**REQUEST FOR BIDS
FOR
CONSTRUCTION
FOR
CVAG OFFICES - TENANT IMPROVEMENTS PROJECT
PROJECT NO. CV-2026-TIP-01**

ADDENDUM

Addendum Date: May 20, 2026

**CVAG Offices – Tenant Improvements Project (TIP)
Project No. CV-2026-TIP-01**

ENLARGED TOILET 105 SCALE: 1/2" = 1'-0" 5

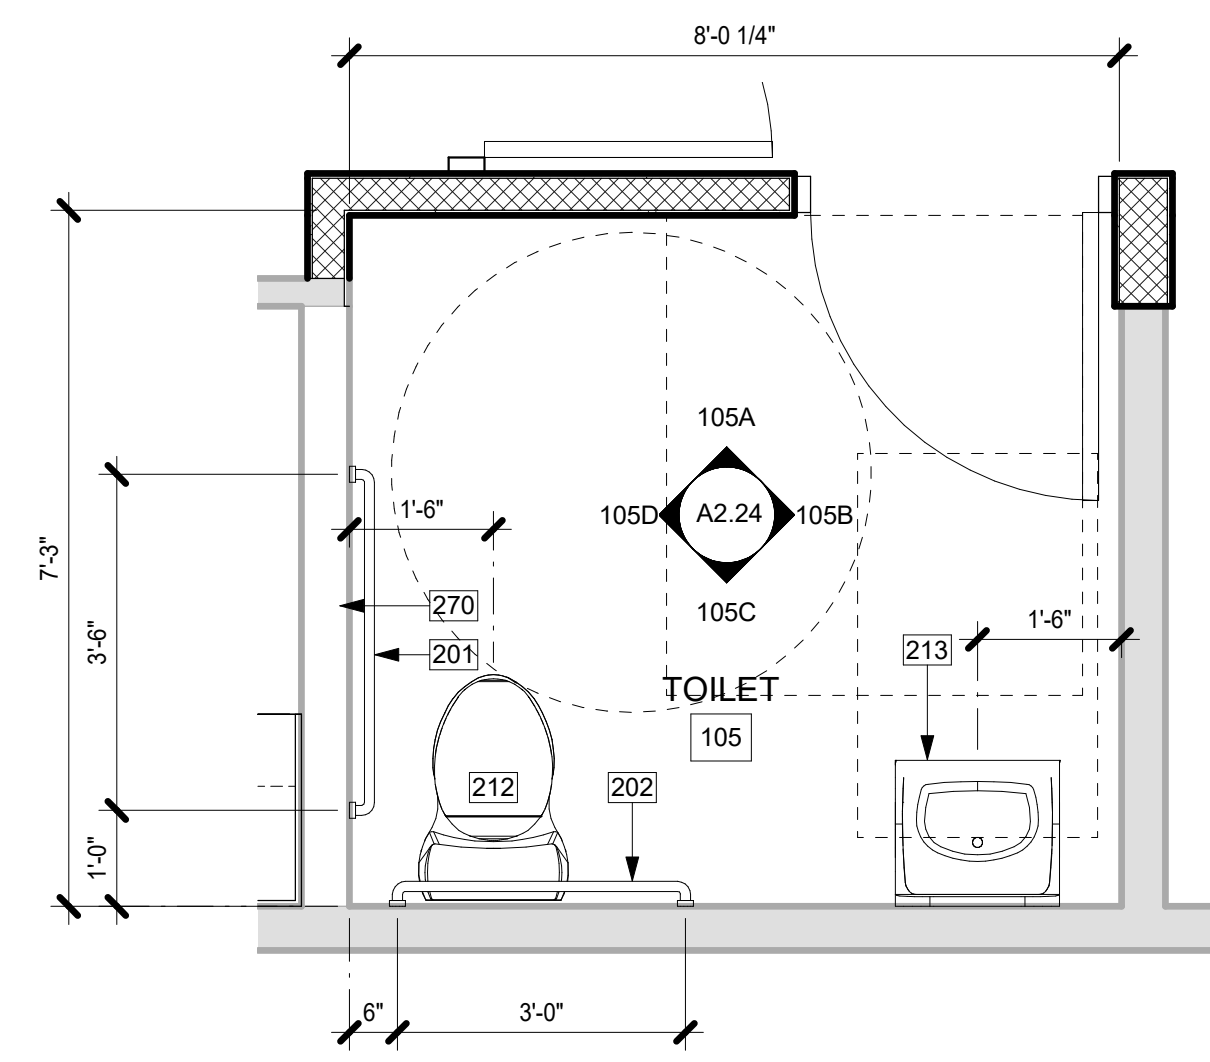
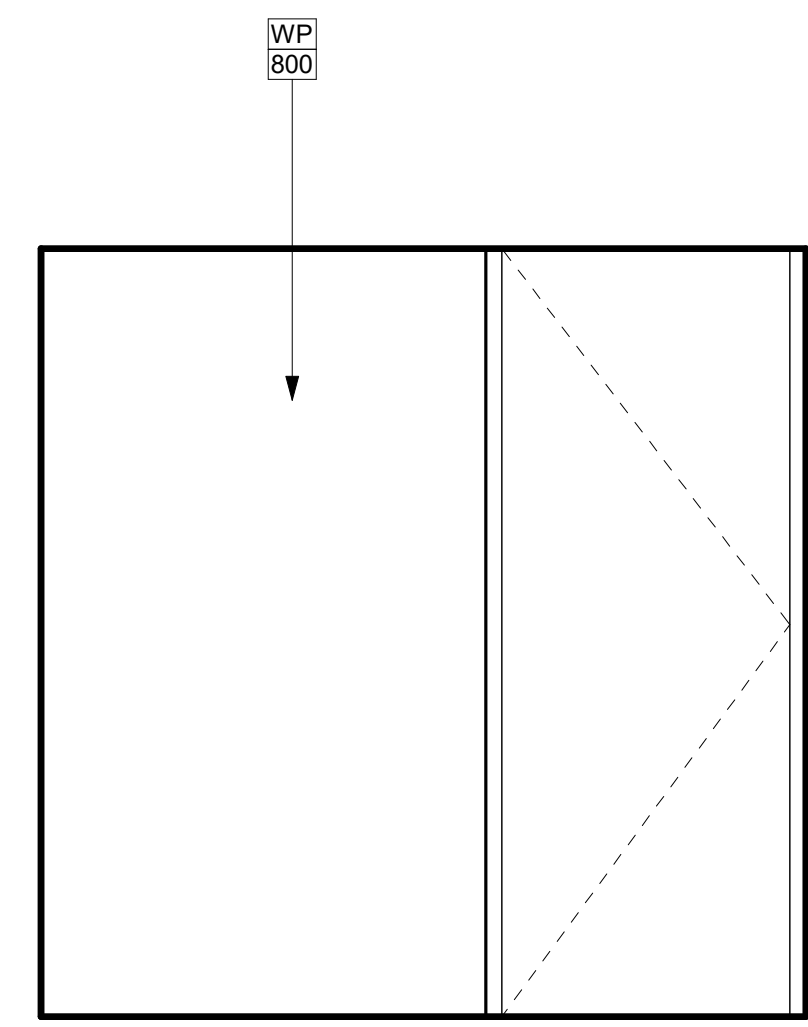
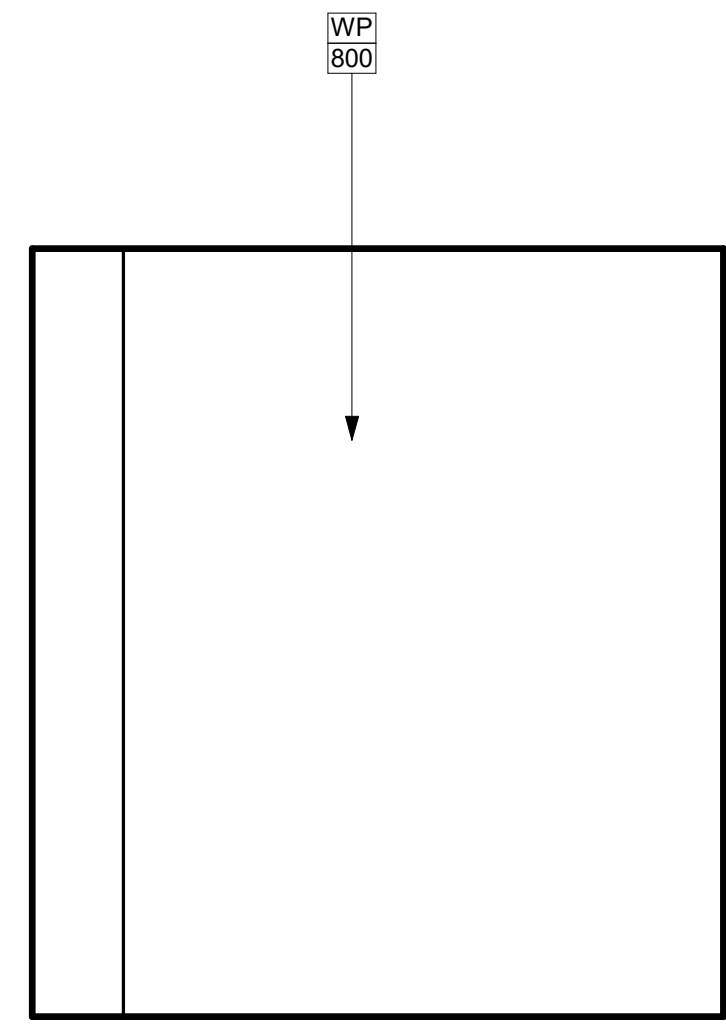
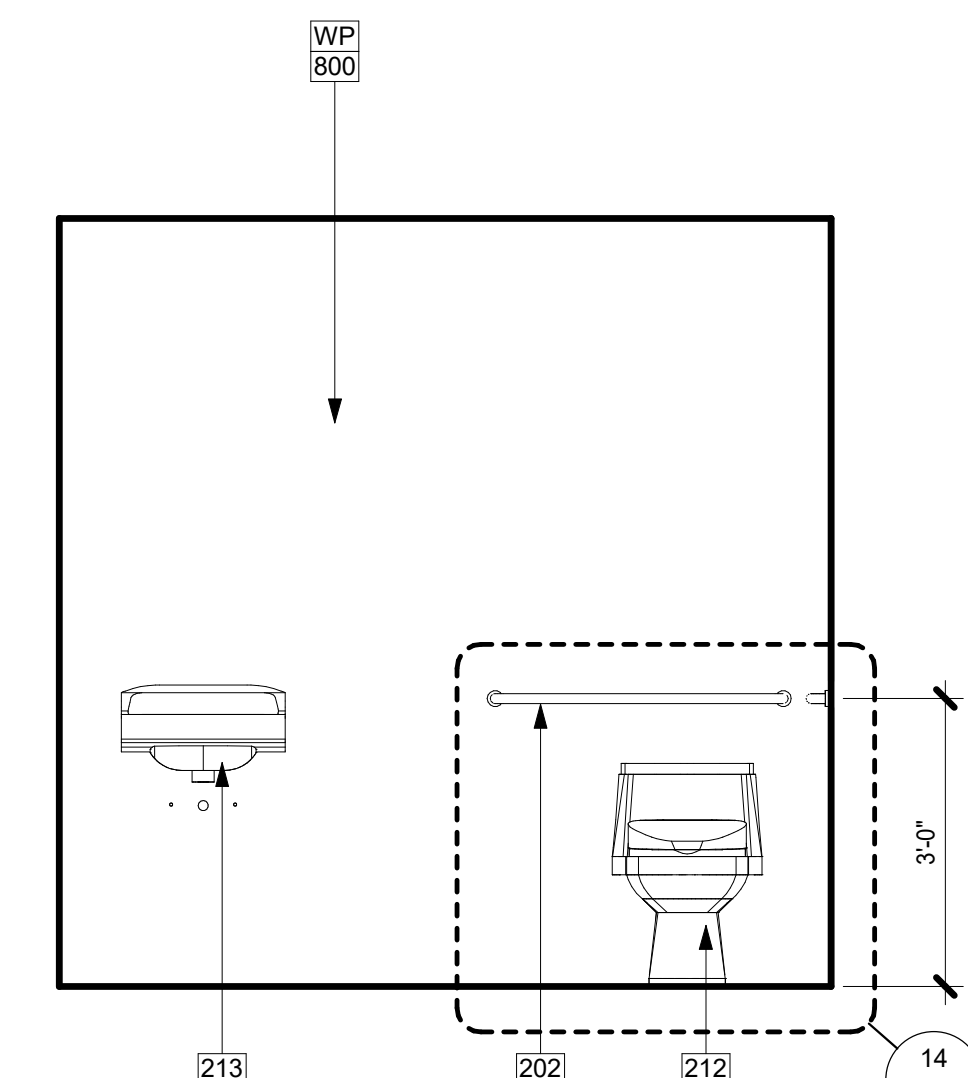
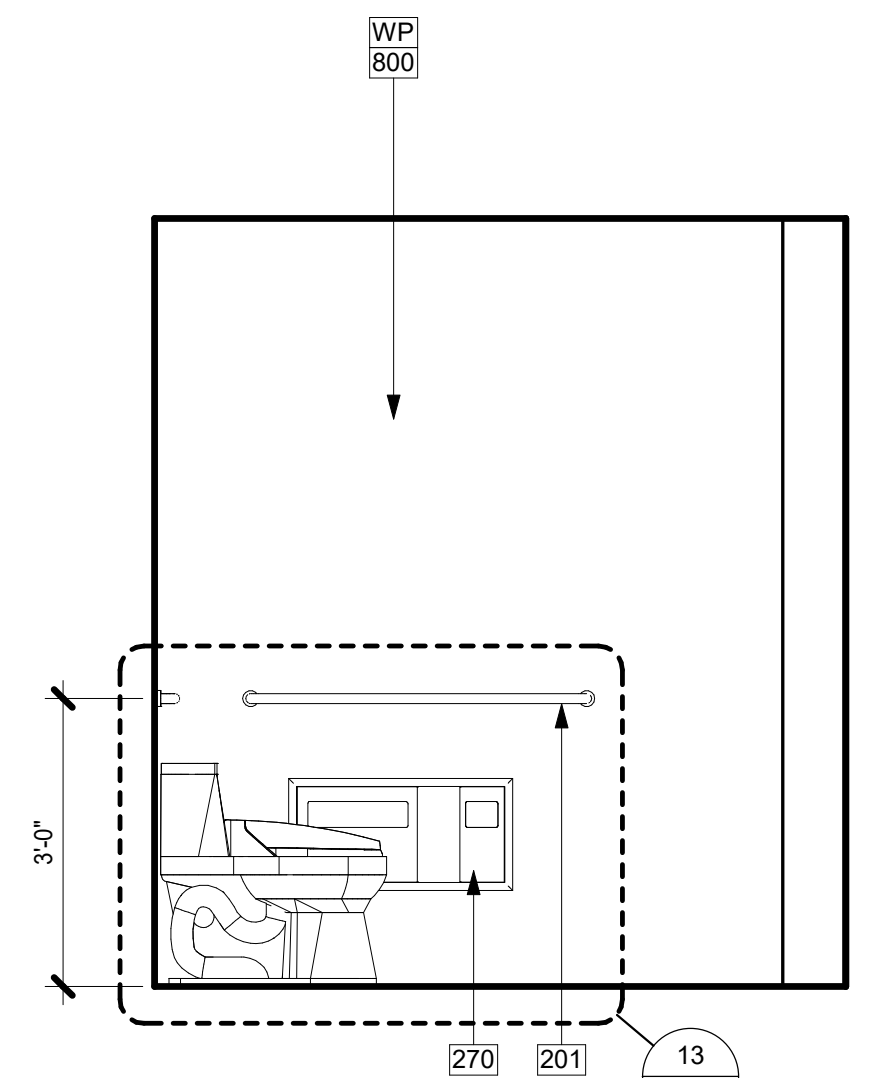
26. **Question:** Please confirm full scope for the new single-user restroom, including demolition, new plumbing, venting, exhaust, lighting, accessories, signage, waterproof/mold-resistant gypsum board, tile/paint finish, and ADA compliance.

Response: *Full scope for the new single-user restroom can be seen at 1/A2.21, 2/A2.21, 3/A2.21, 4/A2.21, 5/A2.24, 3/M3.00, 4/M3.00, 4/E3.01, 3/E3.01, 2/E3.01, 1/E3.01, 4/E3.04, 1/P3.00, & 3/P3.00.*

Project Status
A7.10

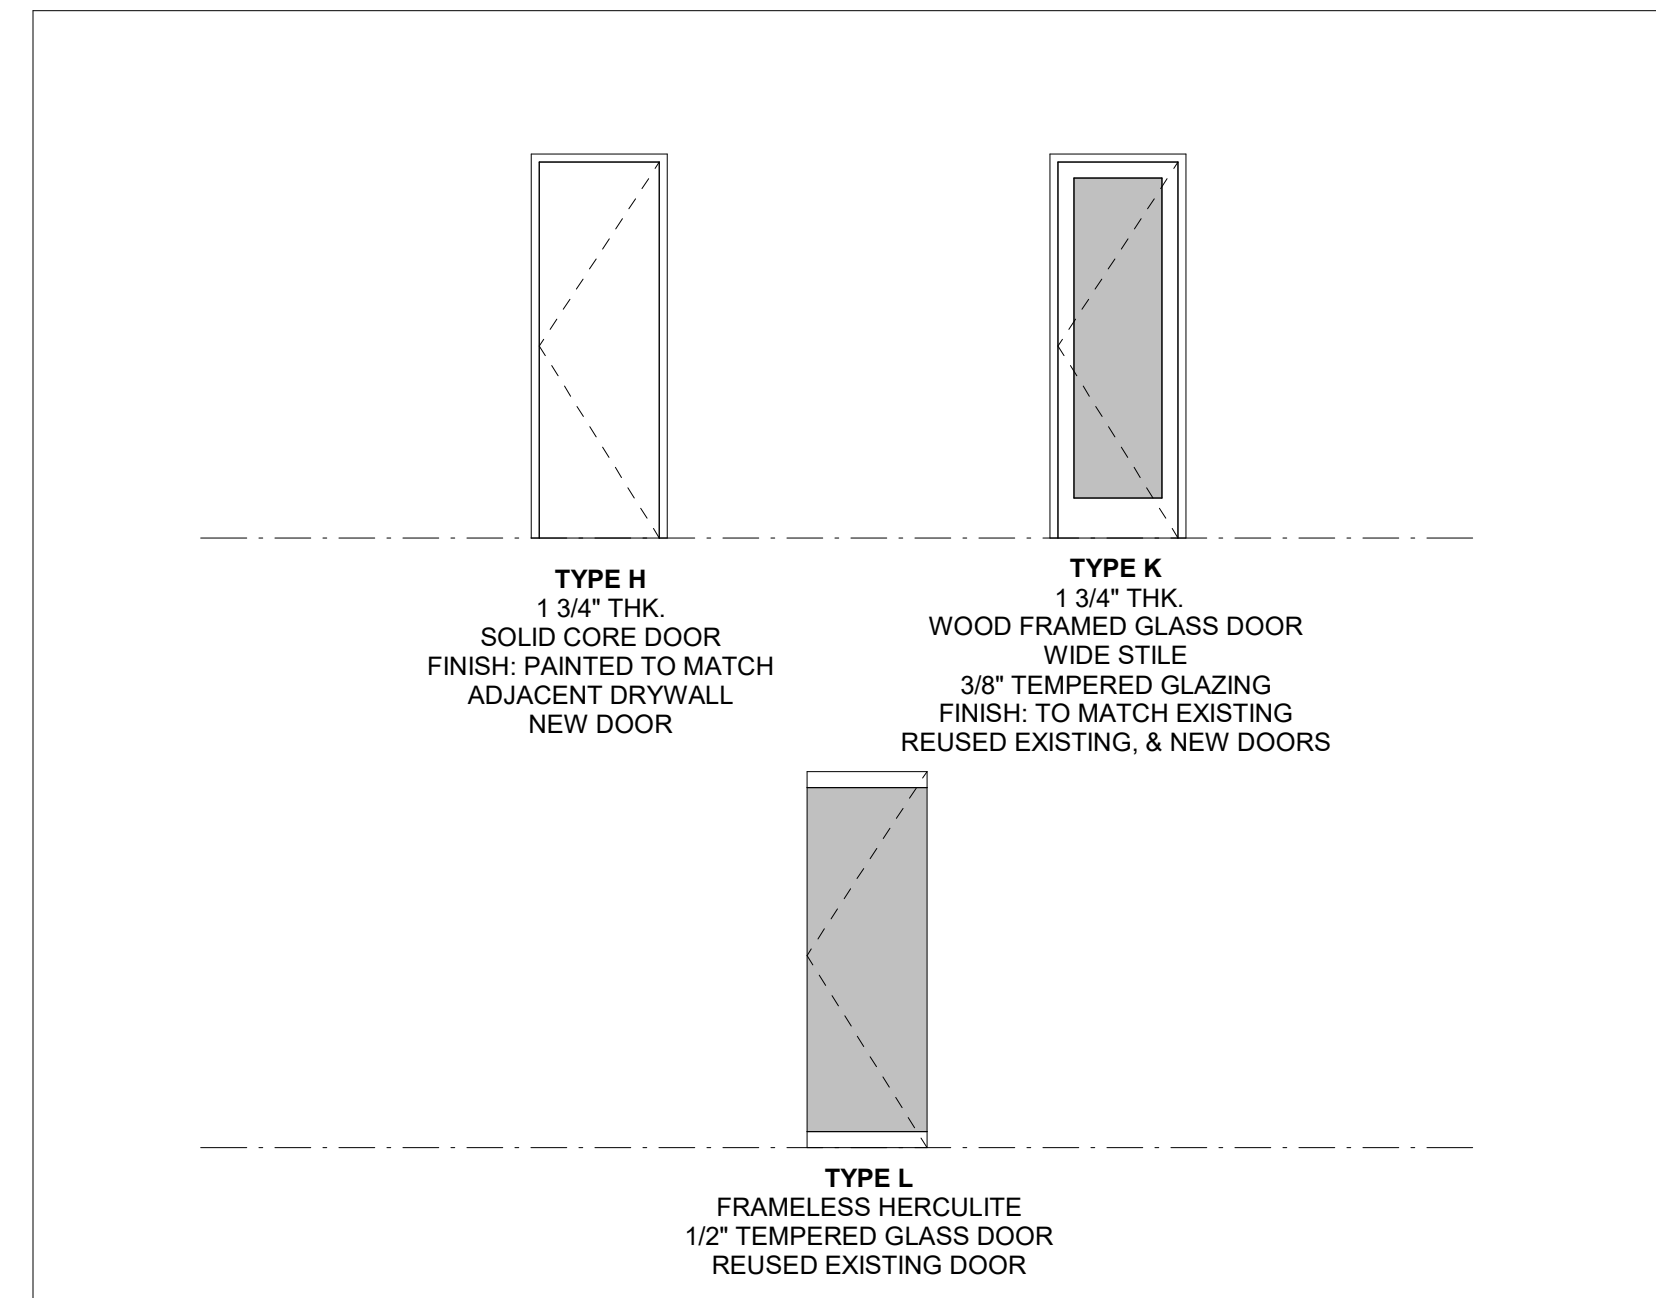
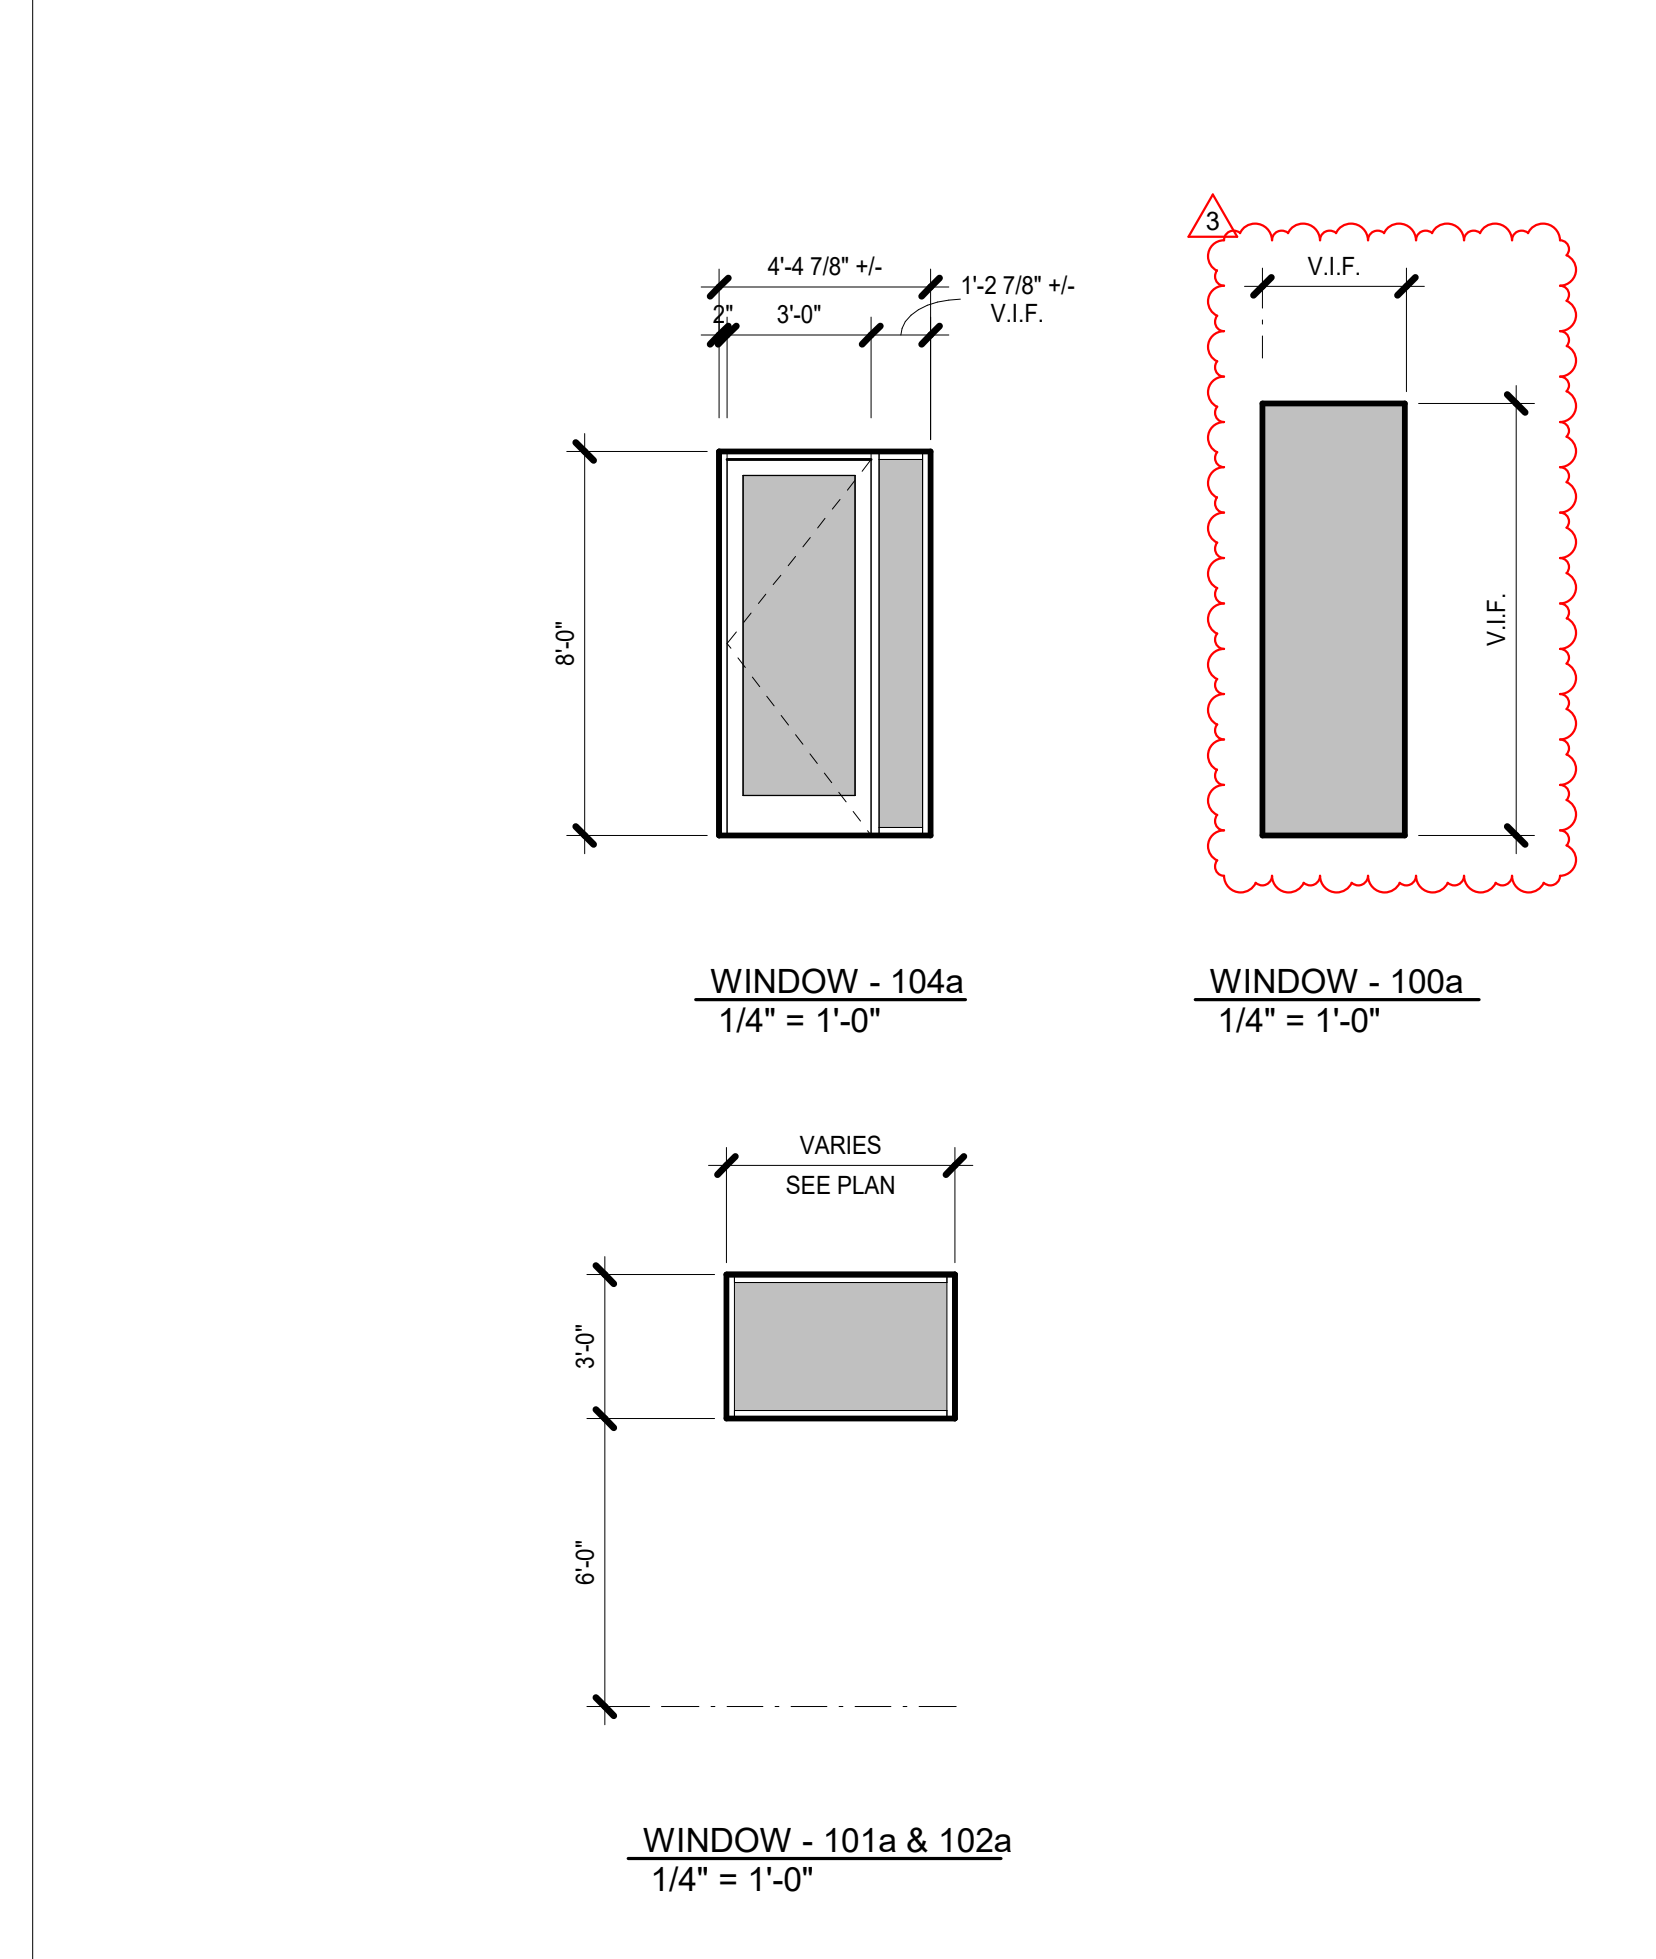
21. **Question:** Please provide the full window schedule and specify profile, glazing type, thickness, safety glazing requirements, and color for the infill glass panel noted to match existing.

22. **Question:** Please provide Finish plans and schedule with specifications.

Response: *Door 110A is no longer a reused door, it is now a new door. Reference Delta-3 on sheets A2.21, A2.24, & A7.10. Contractor to perform a site visit to verify door trim finish specs, as all new doors are to match existing.*

Response: *Missing window 100a has been added to sheet A2.20 & A7.10.*

Response: *A full window schedule has been provided on revised sheet A7.10.*

Response: *A floor finish plan has been provided on sheet A7.10. The new flooring specifications are called out in the keynotes on this page.*
